寄件者: 陳灝然
寄件日期: 2025年08月03日星期日 22:59
收件者: tpbpd/PLAND
副本: Peter Pak Lun NGAN/PLAND
主旨: A/NE-LYT/841 補充資料
附件: 31064-R01-02.pdf
類別: Internet Email

Traffic Impact Assessment for Section 16 Planning Application A/NE-LYT/841 for Proposed Temporary Open Storage of Construction Materials and Machineries with Ancillary Facilities for a Period of 3 Years and Associated Filling of Land at Various Lots in D.D. 83, Lung Yeuk Tau, New Territories

TRAFFIC IMPACT ASSESSMENT REPORT

Reference: 31064-R01-02

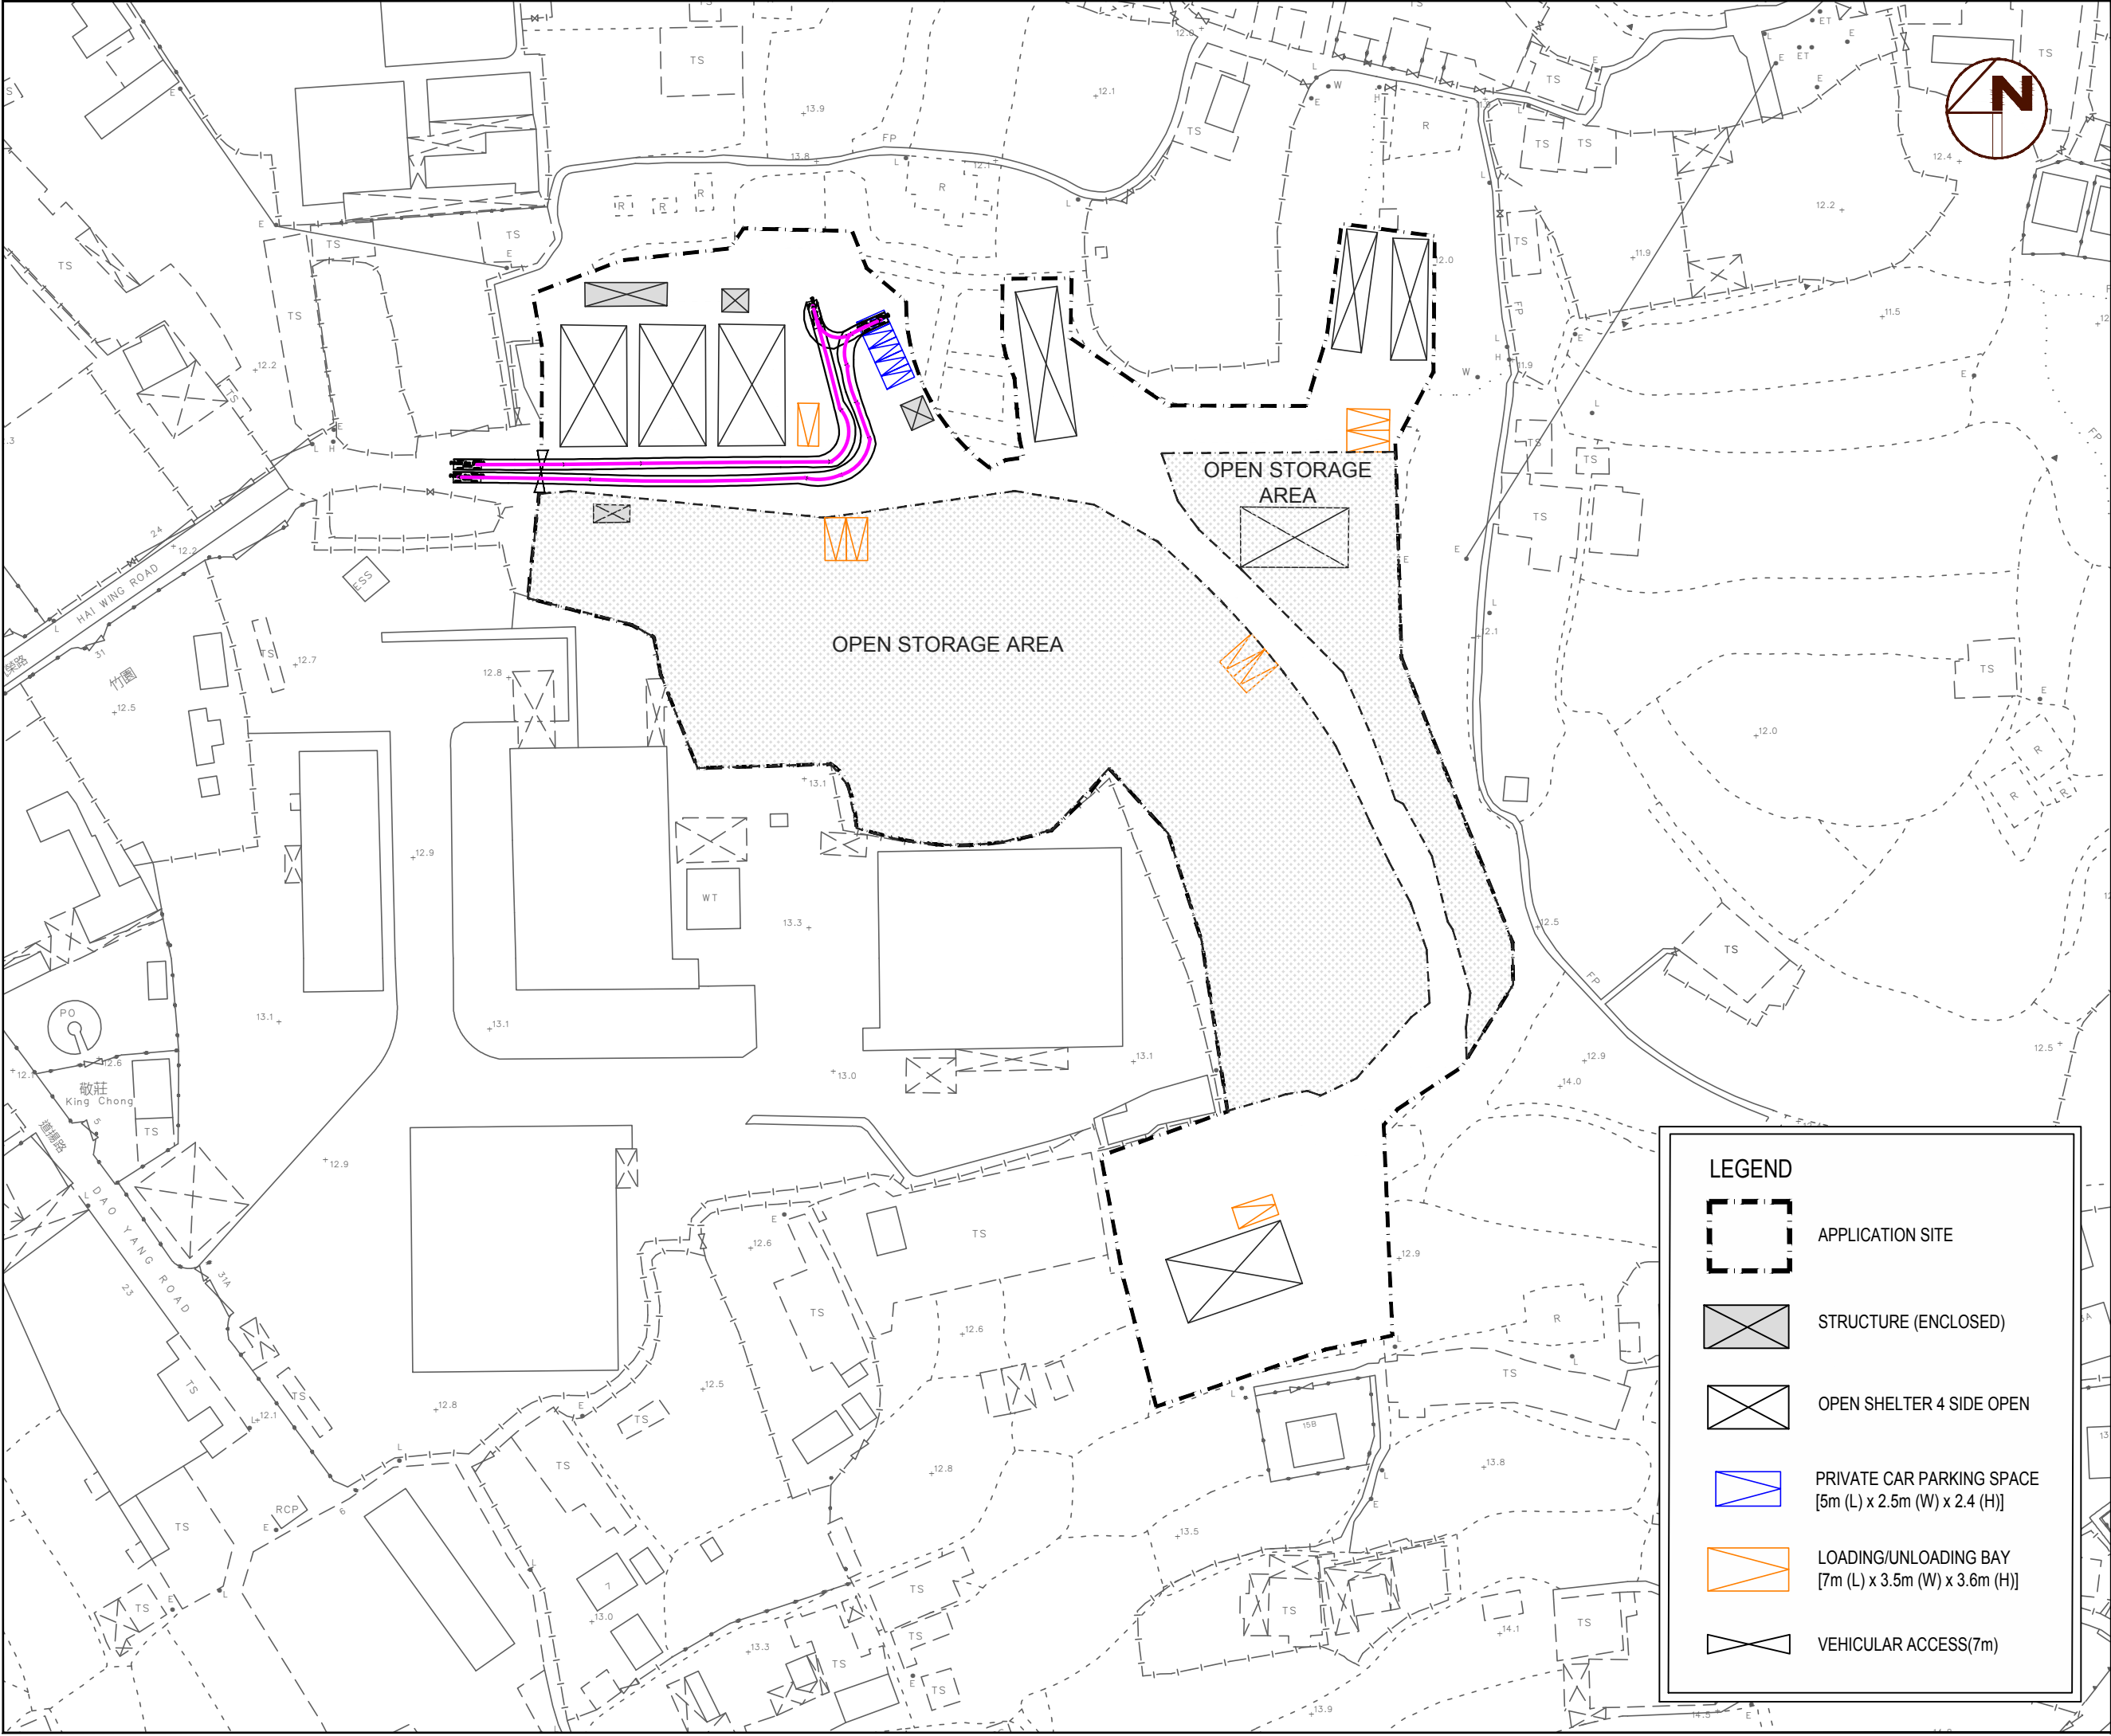
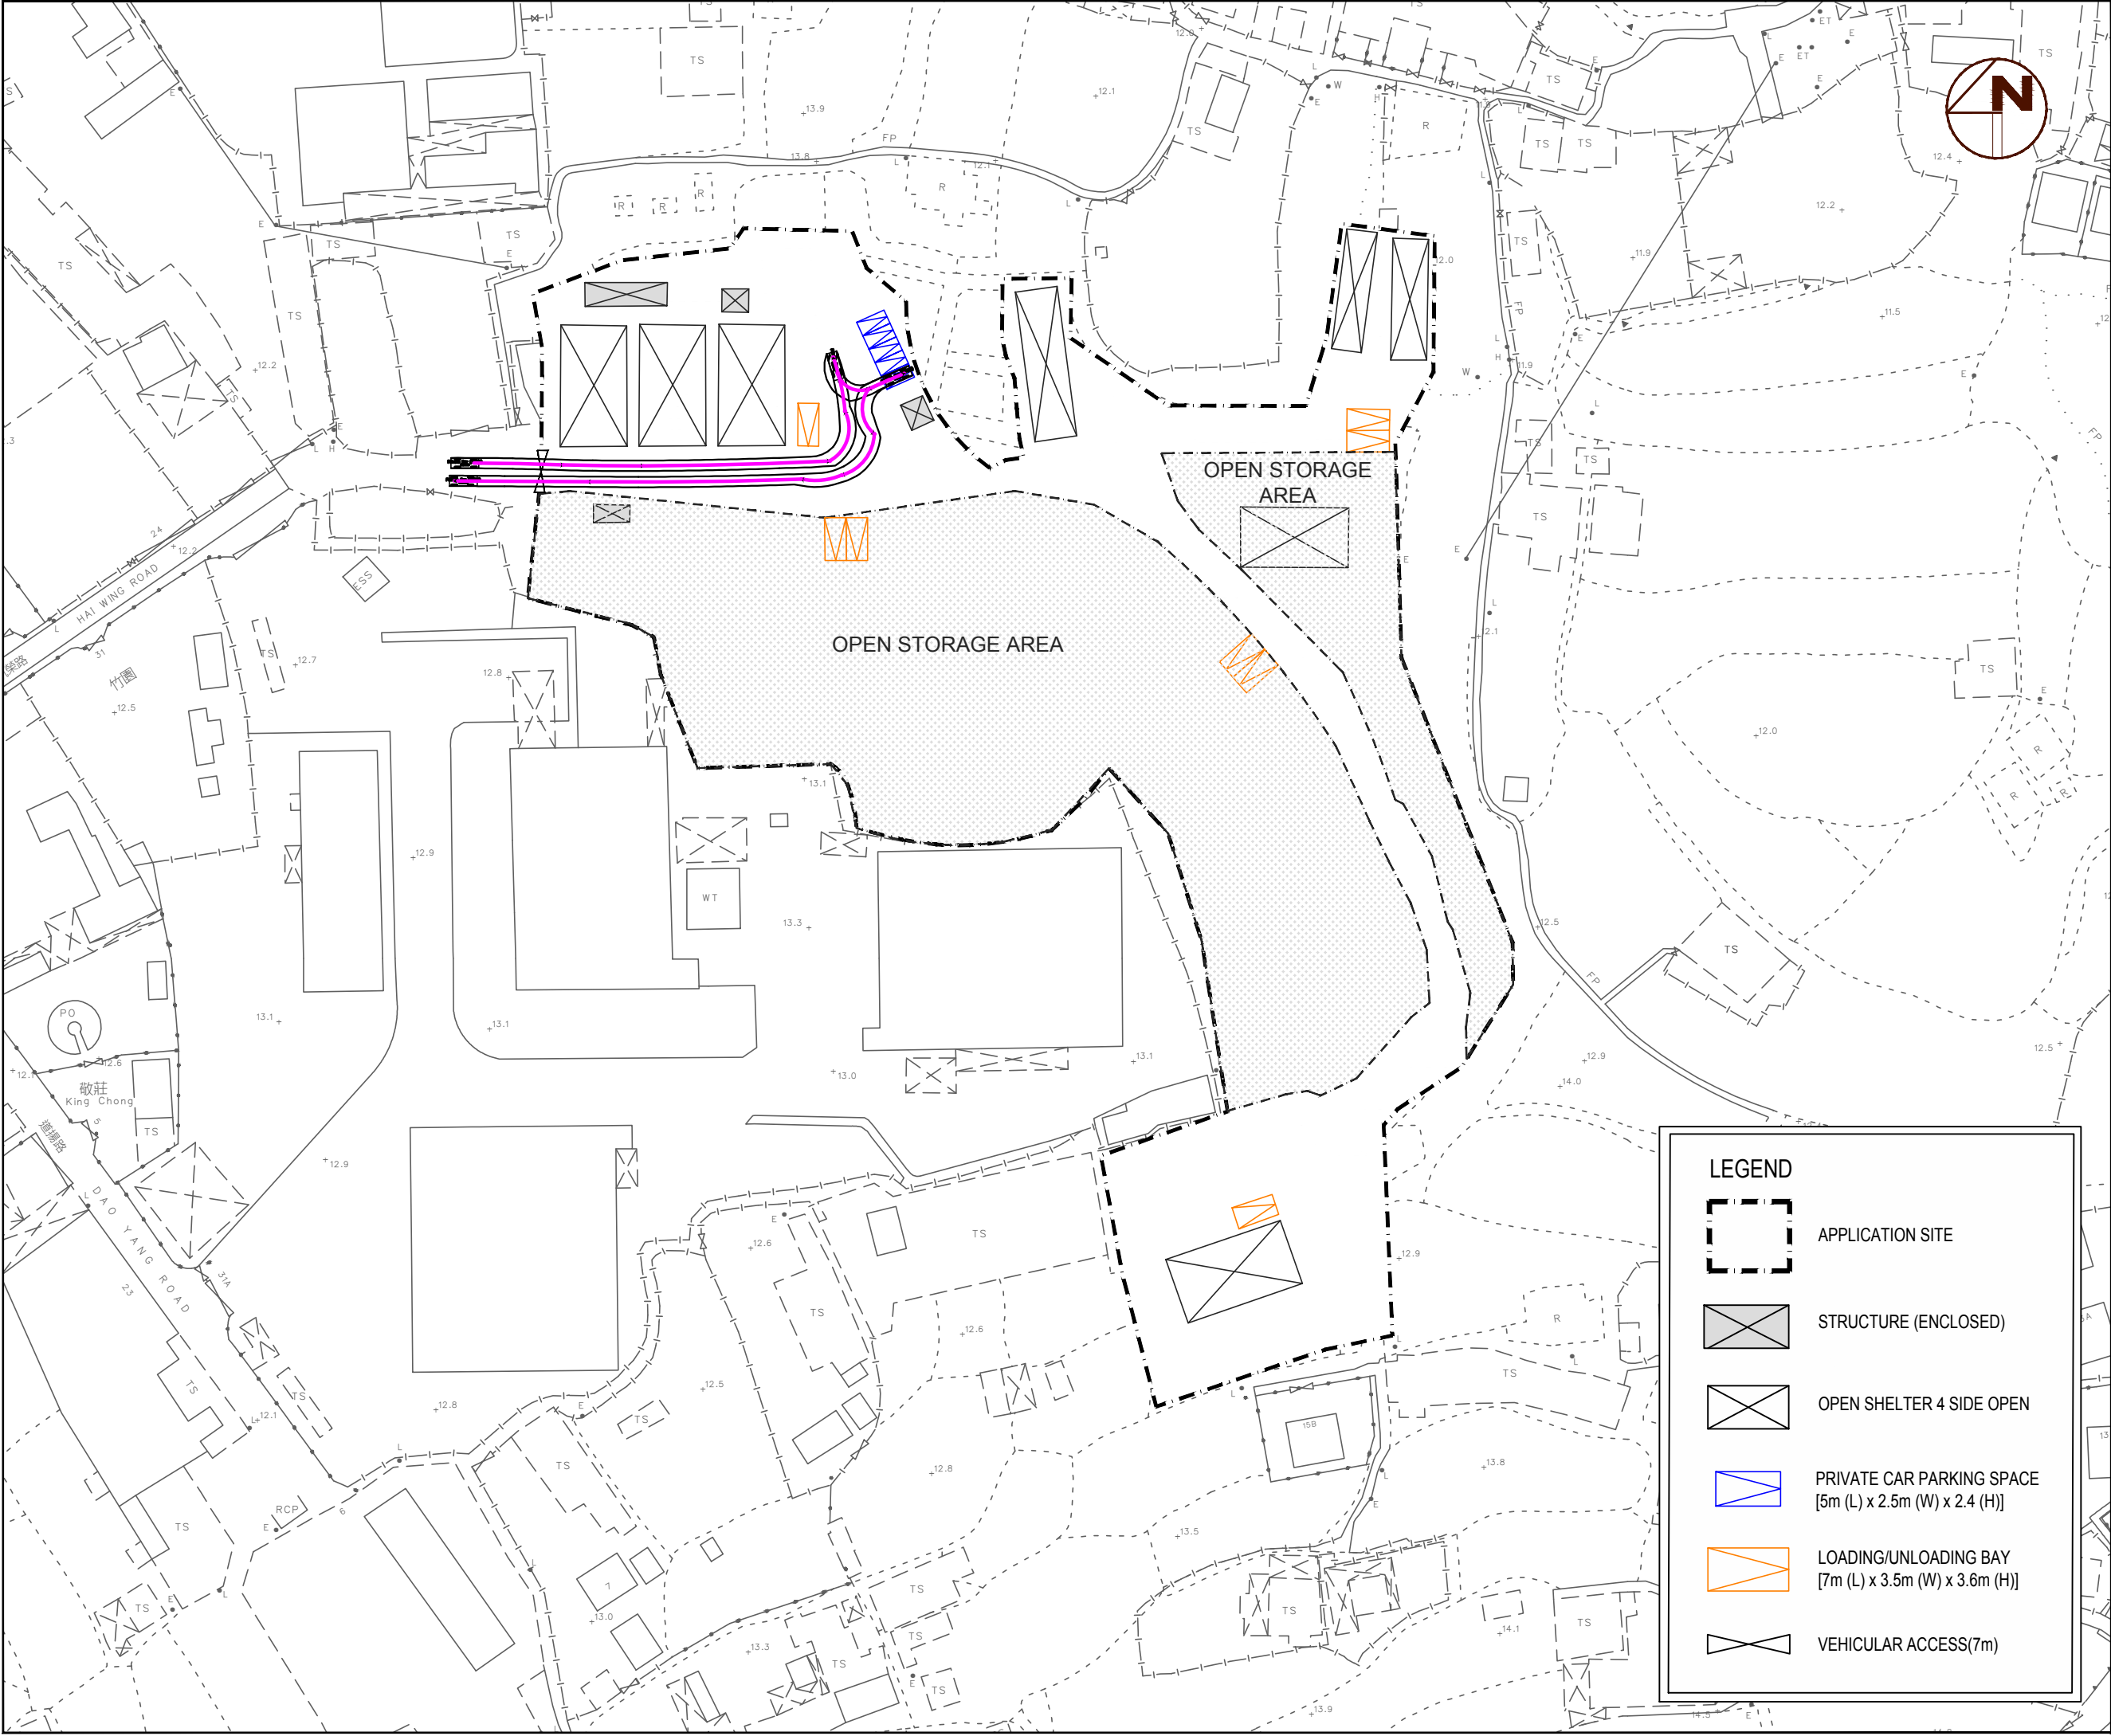
No	Transport Department's Comments	Responses
6	<p>(31.7.2025)</p> <p>Section 5.2: The applicant should advise the dimensions of vehicles used in swept path analysis and supplement the swept path diagrams for the maneuvering of vehicles from Sha Tau Kok Road – Lung Yeuk Tau into the Site as well as from the Site to Sha Tau Kok Road – Lung Yeuk Tau.</p>	<p>(1.8.2025)</p> <p>The swept path analysis has been conducted using a 7m long Light Goods Vehicle (LGV), which is the maximum size permitted for site access. Additional swept path diagrams showing maneuvering to/from Sha Tau Kok Road – Lung Yeuk Tau are provided in Appendix B (Figures SP-01 to SP-06).</p>
7	<p>(31.7.2025)</p> <p>Figures Nos. 3.3, 4.1 and 4.2: The applicant should provide the breakdown of vehicle flows (left-turning, straight ahead, right-turning and U-turning) from each arm of Junction B for reference.</p>	<p>(1.8.2025)</p> <p>The total inflow to the roundabout and the corresponding internal circulating flows were adopted for the capacity assessment. These flows have been reviewed, and the relevant figure has been updated accordingly. Should breakdown of turning movements be required, the applicant is prepared to provide supplementary analysis upon request.</p>
